**CITY OF TEMPE
DEVELOPMENT REVIEW COMMISSION**

**Meeting Date: 12/12/2023
Agenda Item: 6**

ACTION: Request a Use Permit to allow a second-story walk deck addition for a single-family residence for the **LEWIS RESIDENCE**, located at 921 South Roosevelt Street. The Applicant is MNF Design Drafting & Planning LLC.

ZUP230076 Use Permit to allow a second story addition for a roof-top deck on a single-family residence.

SITE PLAN
 SCALE: 1" = 10'-0"

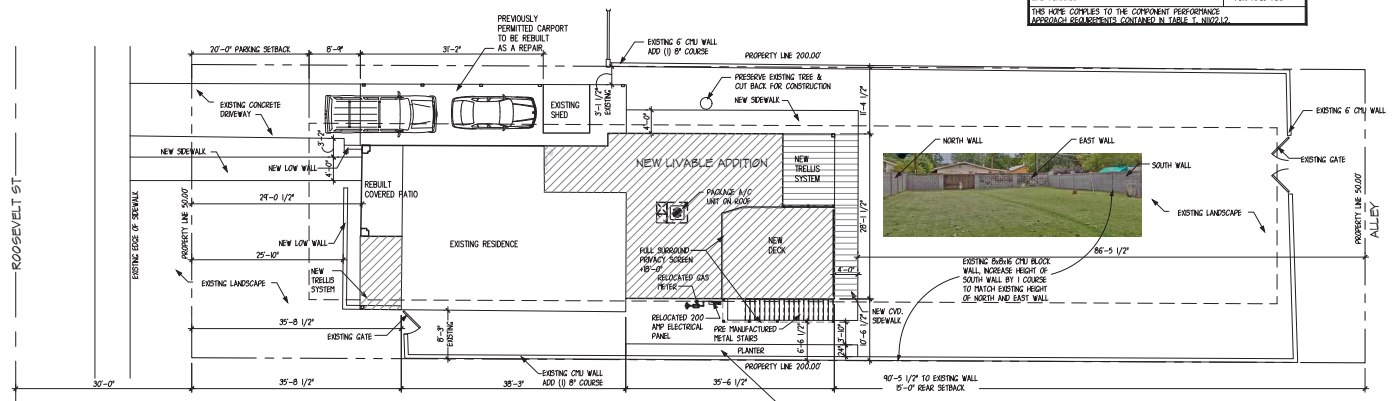
4. **A landscape buffer shall be added on the ground level adjacent to the addition on the north and south sides of the structure to provide a mature plant height of 10-20' without impact to walls.**

5. **A landscape buffer shall be added on the ground level adjacent to the addition on the north and south sides of the structure to provide a mature plant height of 10-20' without impact to walls.**

- a. **If raised planter box is used, the box shall be independent of the existing cmu wall with water barrier between wall and planter to avoid damage to existing wall.**

- b. **Ficus nitida shall not be used as a hedge adjacent to the block walls on either side of the property.**
 - c. **If narrow trees or tall shrubs are proposed in the planter box on the south side, plants should be planted 3' from the existing wall and spaced horizontally to fill the space depending on plant species and planted size.**

PLACE TALL GREEN SHRUB LANDSCAPE BUFFER IN GRADING OR RAISED PLANTER BOXES PER THE DISCUSSIONED PLANT SPEC LIST AND PROPOSED DRAFT CONDITIONS SEE PAGES FOR REFERENCE ONLY.

NOTE:
 PROVIDE LANDSCAPE SCREENING ALONG THE SOUTH WALL SUFFICIENT ENOUGH TO SCREEN THE PROPERTY TO THE SOUTH FROM THE STREET. THE CONTRACTORS VERIFY WITH CONTRACTOR THE TYPE AND LOCATION OF ALL LANDSCAPE MATERIALS.

221 SCREEN WALL WOOD SLAT TO STEEL COLUMN DET. SCALE: 3/4" = 1'-0"

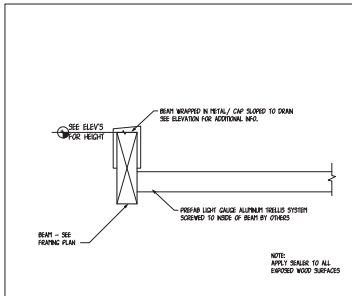
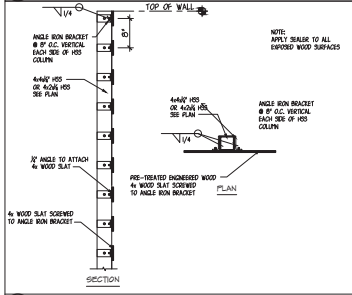
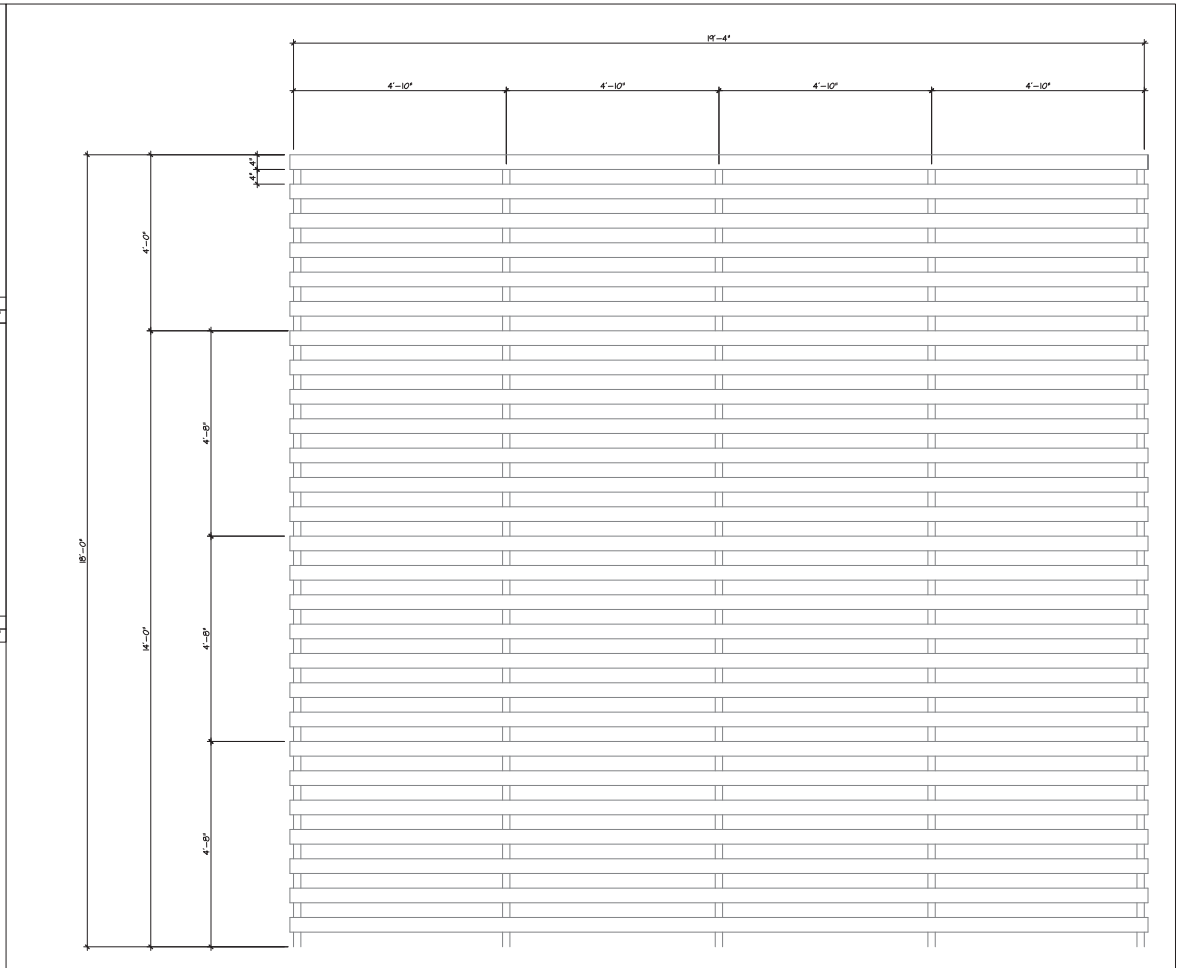
2. *Nuisance arising from the emission of odor, dust, gas, noise, vibration, smoke, heat or glare at a level exceeding that of ambient conditions*; The site is within a quarter of a mile of an active railroad track, arterial street, downtown Tempe and less than a mile from the airport flight path. The proposed second story deck is proposed to have a 72" high privacy screen surrounding the deck.
